JOHNSON COUNTY, KENTUCKY SECTION 202 PROJECT
DOCUMENTATION SUPPORTING REVISIONS TO THE RECOMMENDED PLAN
ALTERNATIVE #2R
DRAFT
ENGINEERING DOCUMENTATION REPORT WITH INTEGRATED
SUPPLEMENTAL ENVIRONMENTAL ASSESSMENT

JUNE 2022

LOUISVILLE DISTRICT

Figure 3: Revised Plan Project Features

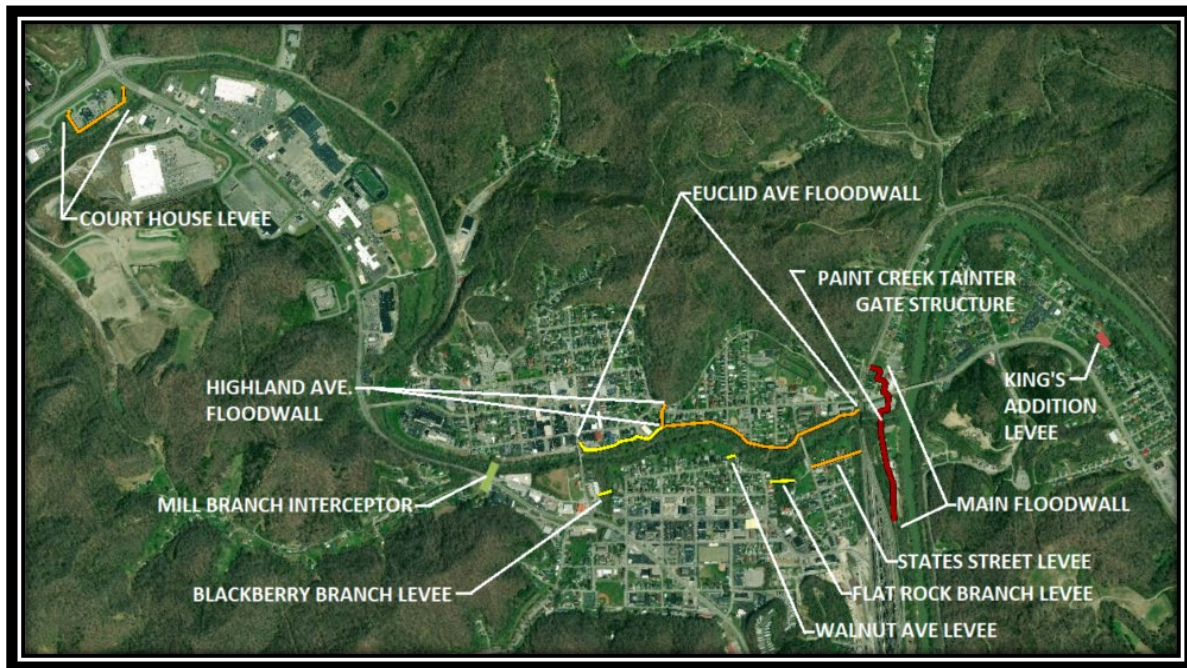
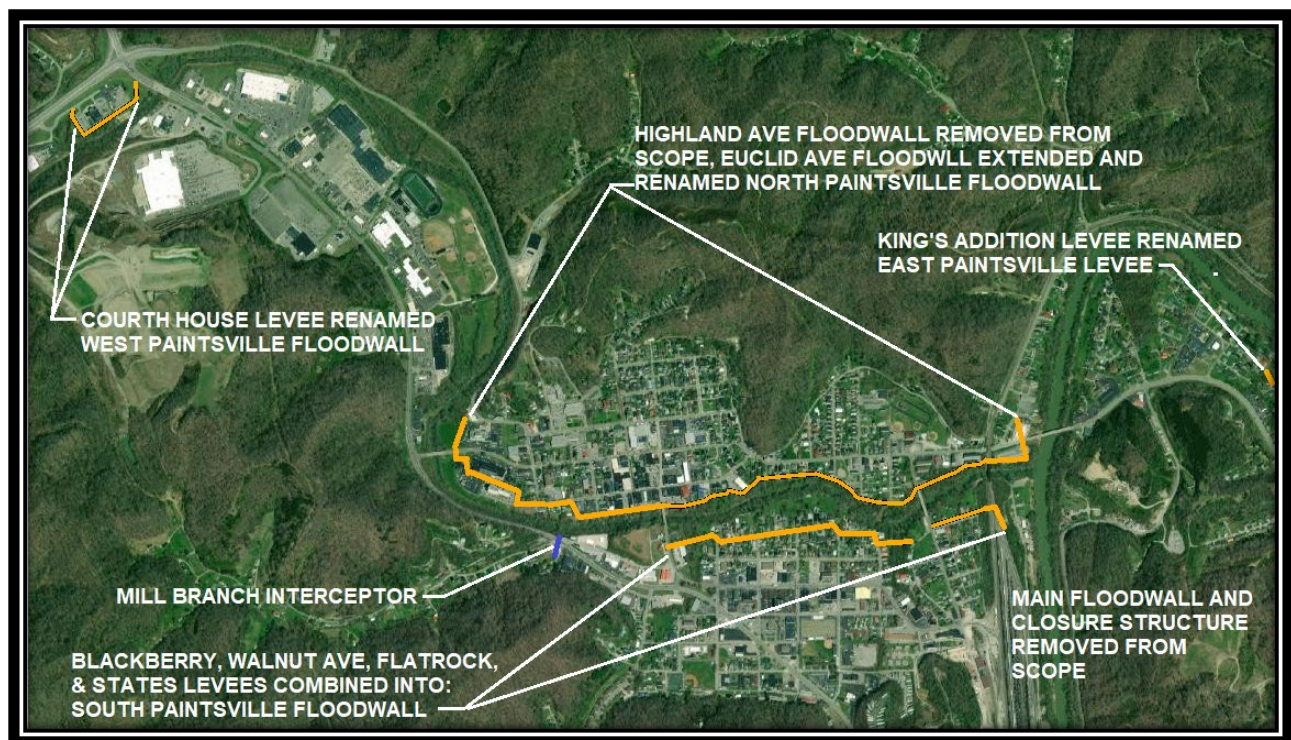
The changes from the 2021 DPR/EA Recommended Plan to the Revised Plan proposed in this document are described in detail in Section 9 above and are summarized below (refer to figures in Section 9).

1. Main Floodwall and Closure Structure (eliminated from Revised Plan). This feature of the Recommended Plan is eliminated in the Revised Plan. The Main Floodwall would have included a closure structure across Paint Creek, near the mouth, with gates, which would close to block backwater during high flood stages on Levisa Fork from entering Paint Creek. In compensation for not blocking the backflow from Levisa Fork, the floodwalls along Paint Creek are increased about 5,300 feet in length and 0.9 feet in height, providing a lower cost and better-functioning project overall (see #4 and #5 below).

In summary, the Main Floodwall is eliminated for the Revised Plan, the North Paintsville Floodwall is extended, and the south segments are partially combined and lengthened for an overall increase in the line of flood protection project-wide of approximately 146%, or an increase of about 4,500 feet overall. Table 2 shows approximate lengths for the three action alternatives. With minor exceptions, all the added lengths of flood protection are floodwall located in developed areas of alleys, parking lots, and lawn. Much of the added length is also relatively low wall and in some locations is actually below grade for seepage cutoff where the existing grade meets the height requirement for protection.

The Revised Plan is made up of four floodwall segments as seen above in Figure 3, providing flood risk reduction to the community and downtown area of Paintsville, KY. The majority of the project includes construction of floodwalls along Paint Creek. The Revised Plan has been developed to provide an improved level of flood risk management, alignment design to minimize impacts to residential and commercial structures, and have minimal impact on the natural or human environment.

Figure 6: North Paintsville Floodwall

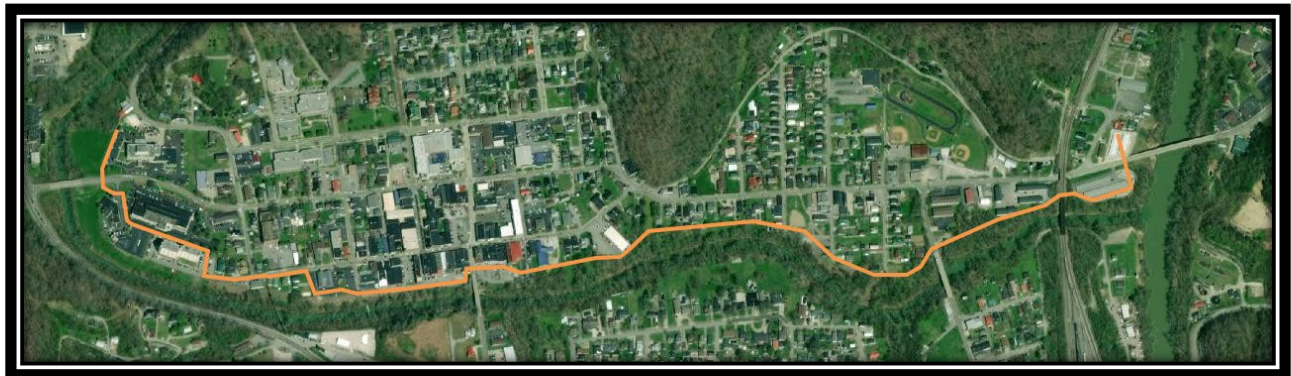
As the alignment progresses downstream it follows a very similar alignment to the Euclid Avenue floodwall from the Recommended Plan with only a slight increase in elevation. The minimum top-of-wall elevation from Sta. 2034+00 to Sta. 2045+00 increased from 612 feet in the Recommended Plan to 614.1 feet for the Revised Plan. The majority of this section is approximately ten feet tall; however, in sections around Sta. 2039+00, 2041+00, and 2044+50, a 10-foot-tall T-wall is used in conjunction with a levee, producing a taller net system.

From Sta. 2045+00 to Sta. 2052+00, floodwall that is typically less than 4 feet tall is utilized, increasing in height by ten inches from the Recommended Plan.

From Sta. 2052+00 to Sta. 2074+00 the alignment remains very similar to the Recommended Plan with a 10-inch increase in height: from Sta. 2052+00 to Sta. 2067. The Revised Plan height is ten feet tall for most of the alignment, then from Sta. 2067+00 to Sta. 2074 is approximately 15 feet tall.

From Sta. 2074+00 to Sta. 2083+00, the north alignment follows the Recommended Plan alignment of the main wall within this area, terminating at a shorter length. Because this portion is replacing the main wall but with a reduction in height, it shortens the tie in location, eliminates one of the road closures, and reduces the height of a second road closure.

Figure 7: South Paintsville Floodwall and Mill Branch Interceptor

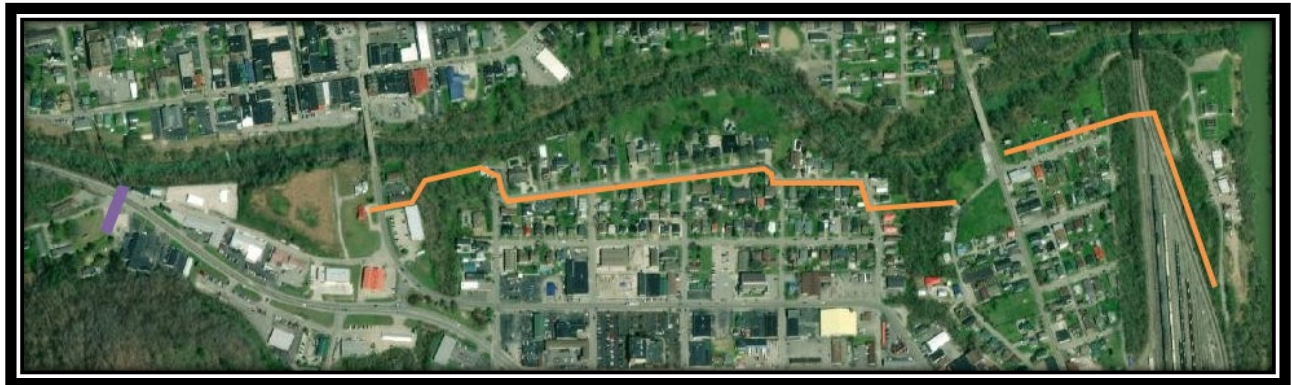
The stationing begins on the west side of Broadway and immediately crosses the street between an apartment and commercial building, and the floodwall would be approximately 5-6 feet tall in this section. East of these buildings the alignment crosses Blackberry Branch. When crossing Blackberry Branch the system will briefly be approximately 30 feet tall while crossing the deepest channel portion. This section at Blackberry Branch will utilize a levee and sheet pile I-wall combo. The creek embankment in this area will be regraded to minimize additional fill required for levee construction. As the alignment approaches Walnut Avenue the stickup height will be in the range of 2-4 feet tall. A portion of Walnut Avenue will be elevated to limit the visual effect and the height of driveway closures. Approximately nineteen structures will remain between the proposed floodwall and Paint Creek once the project is complete. These structures will either (1) not be in the floodplain upon completion of the FEMA letter of map revision or (2) will be offered

The overtopping elevation of the floodwall will be elevation 614.1 feet. Overtopping will be prevented at the tall levee sections by overbuilding those sections by an additional foot of height. The District performed an overtopping evaluation in accordance with Technical Letter No. 1110-2-299 (TL 299) for the proposed Flood Risk Management (FRM) project for the City of Paintsville, Kentucky (Revised Plan). The PDT compared the consequences that would result from a flood event that overtopped the proposed FRM project with the consequences that would result from the same flood event but without the project. Based on the comparison, the District has concluded that overtopping of the FRM project would not likely result in any sudden or unique catastrophic consequences directly resulting from the overtopping event.

Figure 8: Borrow Area

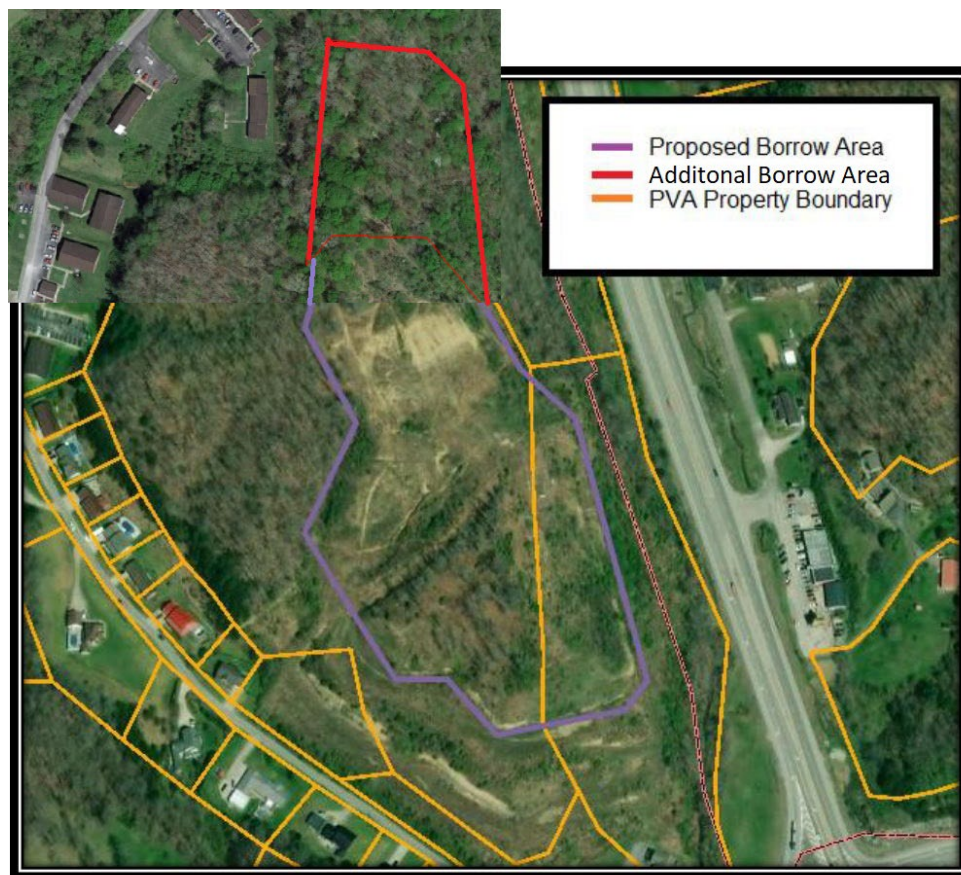
The borrow area identified within the DPR is still anticipated to be used for borrow material. See Figure 8 that shows the previously identified borrow area and the additional area. The PDT team identified additional land for borrow material to ensure the necessary amount and quality of borrow material can be extracted from the land for project use. The proposed borrow area and disposal site identified to support the project is located on the west side of Paintsville on vacant property at the northwest corner of the intersection of US 460 and KY 321. The property has been previously utilized as a borrow/excess site for Non-Federal projects and has sufficient access from Hidden Valley Road. The site is located approximately three miles

requirements from the Recommended Plan to the Revised Plan. The expansion shown in Figure 8 makes up for elimination of a second borrow site at the east end of Carter Lane that had been considered, but would have involved removal of both wooded habitat and several homes and outbuildings. Figure 8 shows a total of approximately 14.5 acres identified for project use. It is anticipated that the project only requires approximately 7.25 acres of borrow material. The larger area was identified to account for any contingency soil that may be needed. Unless contingency conditions prevail, only half the estimated borrow area acreage would be used for implementation of the Revised Plan. Most of the borrow area has been previously disturbed. There is a portion of the identified borrow acreages that still contain wooded areas. Borrow activities would start by utilizing the disturbed, open areas for gathering material. Tree removal will be avoided or minimized within the identified borrow area. The potential tree removal for borrow activities and other project actions as been coordinated under Section 7 with the U.S. Fish and Wildlife Service (USFWS). The USFWS concurred with the USACE determination in a letter dated May 31, 2022.
